EMERGENCY AIRWORTHINESS DIRECTIVE

AD #: 2002-23-51

Send to all U.S. owners and operators of Bell Helicopter Textron Canada (Bell) Model 407 helicopters.

2002-23-51 BELL HELICOPTER TEXTRON CANADA: Docket No. 2002-SW-51-AD.

Figure 1. Correct cup washer direction, installation of

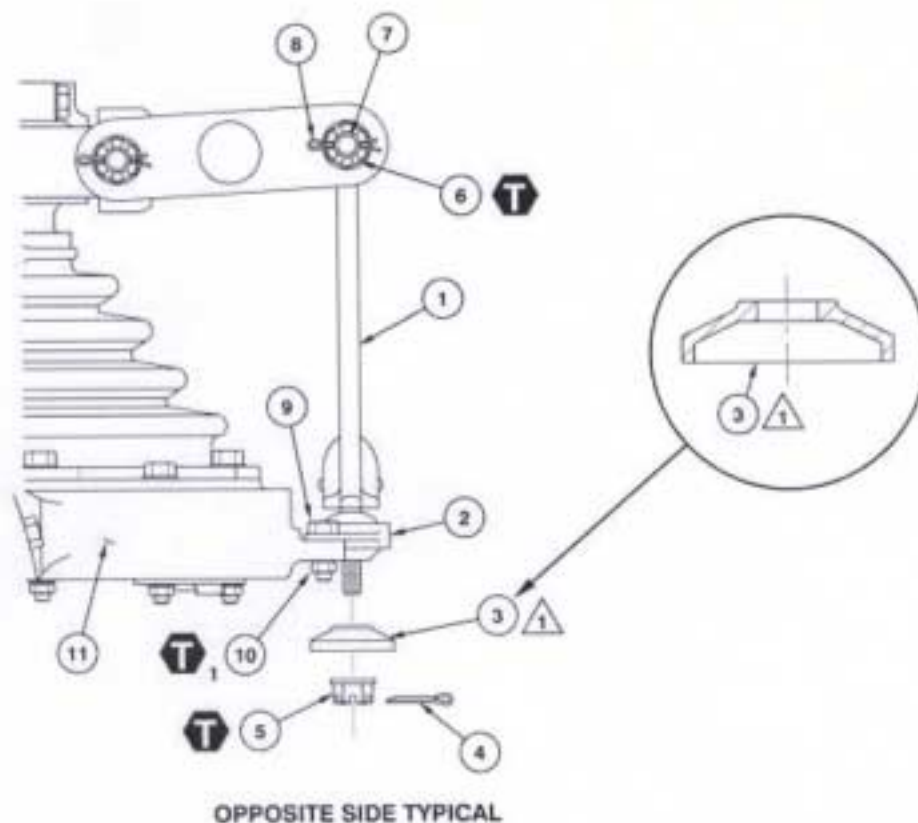
(a) Visually check both cup washers, part number (P/N) 406-010-412-101, for correct installation in accordance with Figure 1 of this AD as follows:

- 1** Washer shown is correctly installed.
2. Washers under bolt head (9) and nut (10) are not shown for clarity.

(1) If both cup washers are correctly installed, no further action is required.

(2) If one or both cup washers are installed incorrectly, remove and replace the swashplate outer ring, each cup washer that was installed incorrectly, and the bearing, liner, and drive link where the cup washer was installed incorrectly. Accomplish the replacements in accordance with Part II of the Accomplishment Instructions in Bell Helicopter Textron Alert Service Bulletin No. 407-02-55, dated October 29, 2002.
